5-1 Log #160 NEC-P05
(Entire Document)

NOTE: The following proposal consists of Comment 5-1 on Proposal 5-1 in the 2004 May Meeting National Electrical Code Committee Report on Proposals. This comment was held for further study during the processing of the 2004 NATIONAL ELECTRICAL CODE. The recommendation in Proposal 5-1 was:

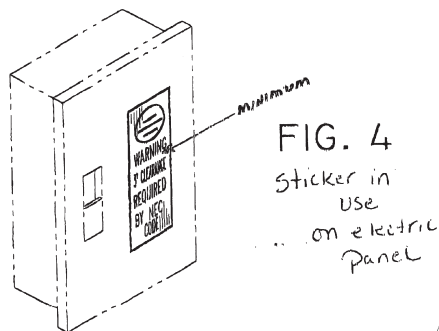
Recommendation: Revise as follows:

2-192 Log #1399 NEC-P02
(Figure 210.52)

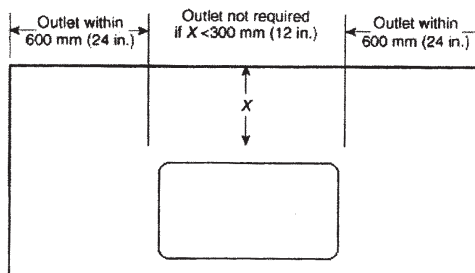
Recommendation: Delete the text from the upper left corner representing the area requiring outlets behind a sink or range in a corner from Figure 210.52: Outlets not required if X < 450 mm (18 in.) .

Panel Statement: The panel disagrees with the submitter and notes that a corner mounted sink that has countertop exceeding the 450mm (18”) dimension does create a usable counter space.

2-193 Log #1463 NEC-P02
(Figure 210.52)

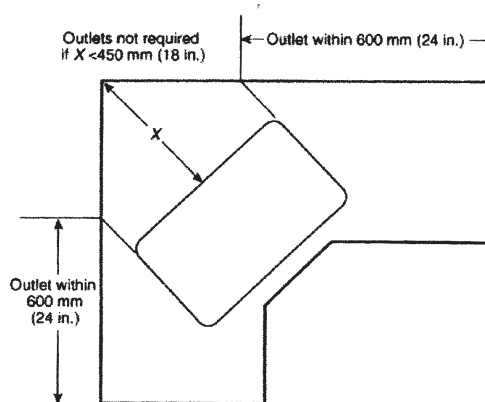
Recommendation: Revise Figure 210.52 as shown:

Substantiation: Having this apply only when the sink or range extends beyond the front of the countertop is not substantiated. When does it apply? When the sink extends 12 in. from the face of the counter? When it extends 1/2 in. from the face of the counter? Accepting this proposal will assist in the uniform interpretation of the code.

Panel Statement: Figure 210.52 is applicable to sinks or ranges mounted in wall counter spaces. The submitter’s concern is already addressed in 210.52(C)(1). The part of Figure 210.52 referenced applies to a sink or range extending from the counter face.

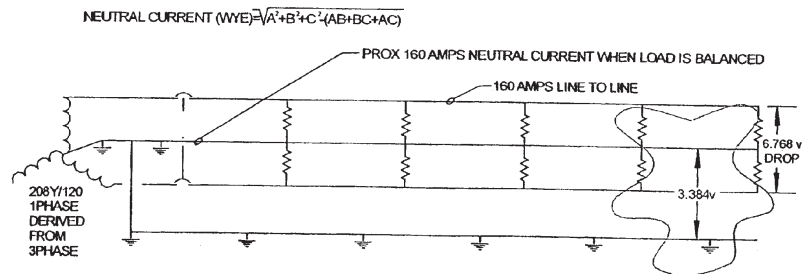
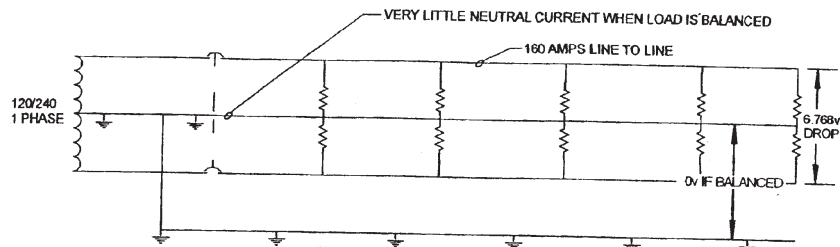
WEAKLEY, K.: Argument against changing from single phase 3 wire to single phase derived from 3 phase 4 wire.

Three wire single phase system derived from a three phase four wire supply. When a momentary current of 250 amps at 208 volts is developed, a potential of 5.2875 volts is on the neutral conductor.

Three wire single phase system. When a momentary current of 250 amps line to line at 240 volts, is developed, a potential of 0 volts is on the neutral conductor.

Calculations; 225 ft of 250 mcm AL conductor,.094 ohms per 1000 ft, 160 amp load, = 3.384 volts drop. A momentary load of 250 amps line to line would create a 5.2875 volt drop on one of the ungrounded conductors.

Figure 2 - Distribution Graph of Connected Load Value Based on Climate Zones

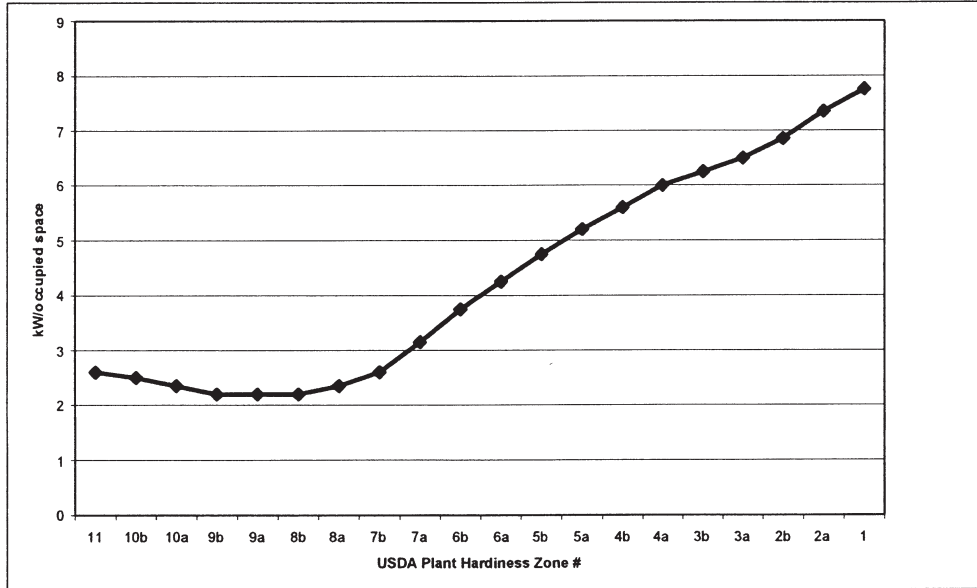
Load data from the electrified parking spaces at different geographical locations was recorded for the coldest month (January). The data, in average measured kW per occupied parking space, was correlated with the USDA zones as shown in Figure 2. A baseline load for small appliances, block heater and other amenity loads was then established to reflect the variations in the recorded load attributed to the daily temperature differences during the month. These values were then increased by a margin of approximately 20%. This margin is based on the expected demands of additional devices identified as likely to be used in the truck in the future and anticipates the increased accessory loads as electrified parking spaces become more available. Figure 2 illustrates the high power

As seen in the graph, there is a baseline load of about 2.2 kW per occupied space, at the several of the temperate climate zones, with an increasing load as temperatures decrease in colder zones and increase in hotter zones.

Figure 690.1(A) Identification of Solar Photovoltaic System Components.

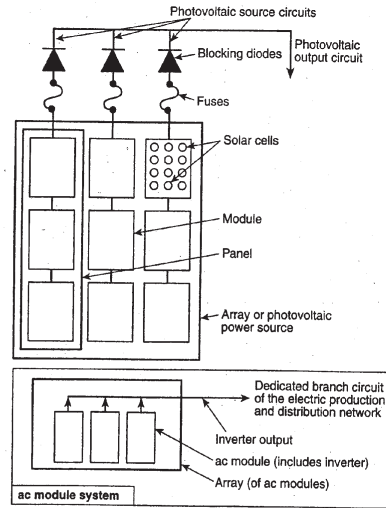
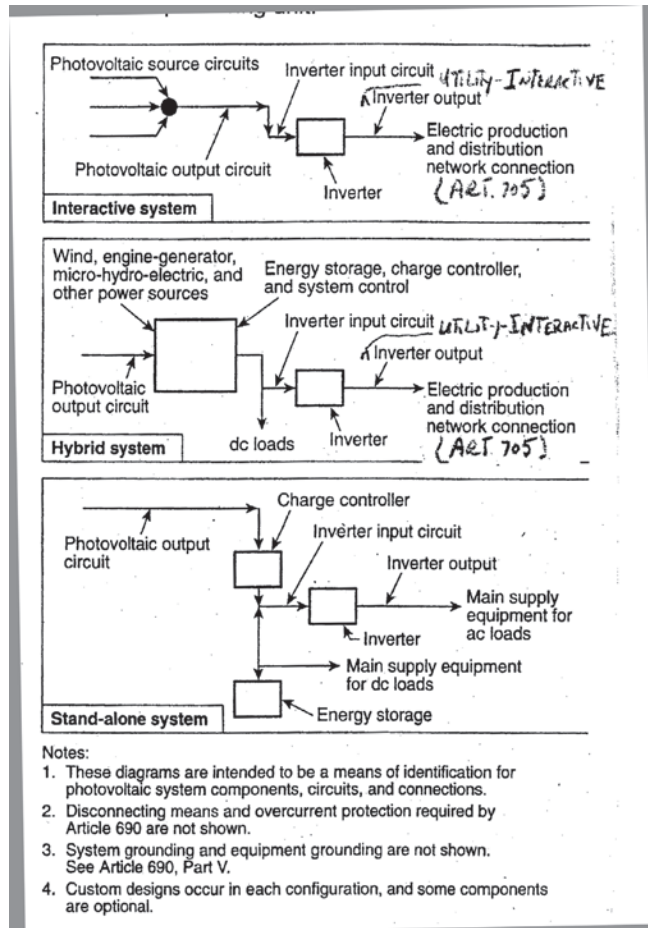
Recommendation: Listed below are the proposed text and the revised figures of Article 690.

Figure 760-61 Cable substitution hierarchy.

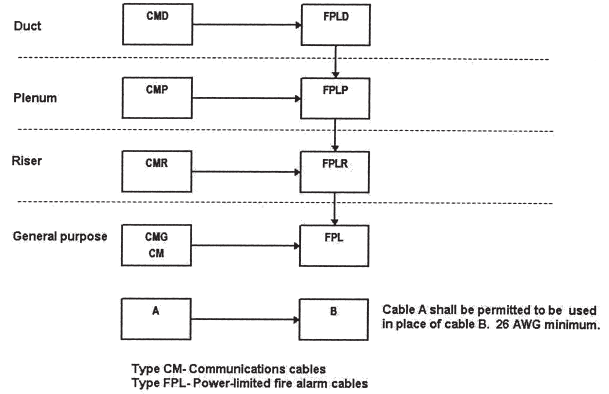
(D) Fire Alarm Cable Substitutions. The substitutions for fire alarm cables listed in Table 760.61 shall be permitted. Type FPLD shall be permitted to substitute for all fire alarm cables in Table 760.61 and Figure 760.61. Where substitute cables are installed, the wiring requirements of Article 760, Parts I and III shall apply.

Figure 770.154 Cable substitution hierarchy.

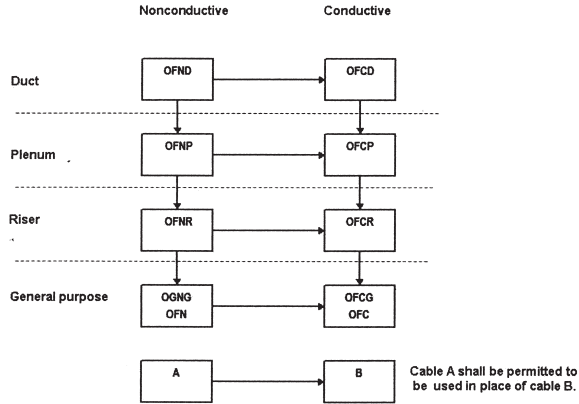
(F) Cable Substitutions. The substitutions for optical fiber cables listed in Table 770.154 shall be permitted. Type OFND shall be permitted to substitute for all cables in Table 770.154 and Figure 770.154. Type OFCD shall be permitted to substitute for conductive optical fiber cables in Table 770.154 and Figure 770.154.

Figure 800-154 Cable substitution hierarchy.

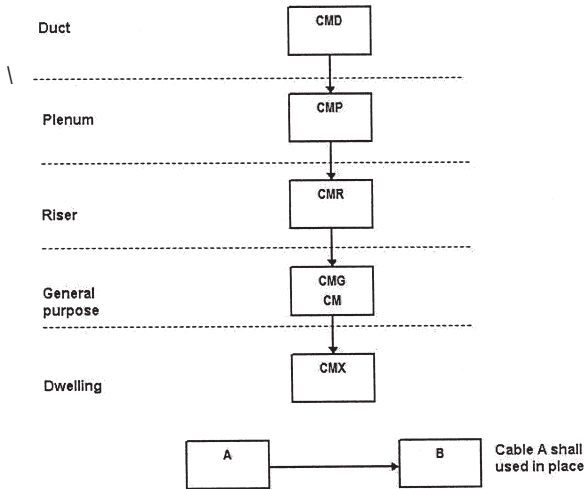
(G) Cable Substitutions. The uses and permitted substitutions for communications cables listed in Table 800.154 shall be considered suitable for the purpose and shall be permitted. Type CMD shall be permitted to substitute for all cables in Table 800.154 and Figure 800.154.

16-325 Log #50 NEC-P16
 (Figure 820.154)

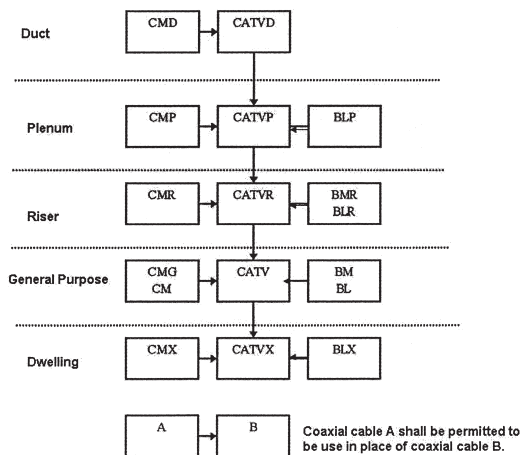
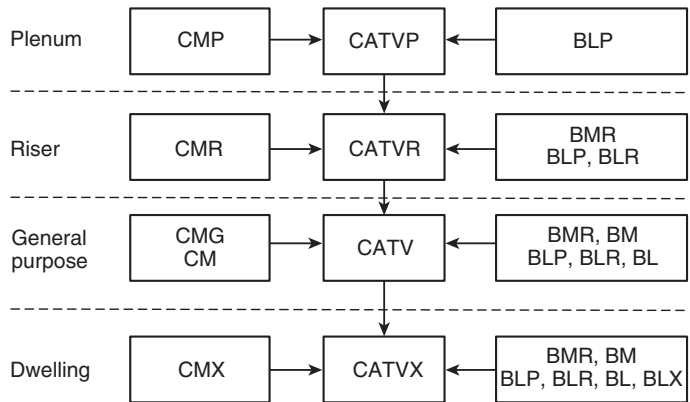
Substantiation: Table 820.154 permits broadband cables are permitted to substitute for CATV cables so broadband cables should be in Figure 820.154 also. “Dwellings” was changed to “dwelling” for editorial consistency with the other labels; they’re all singular.
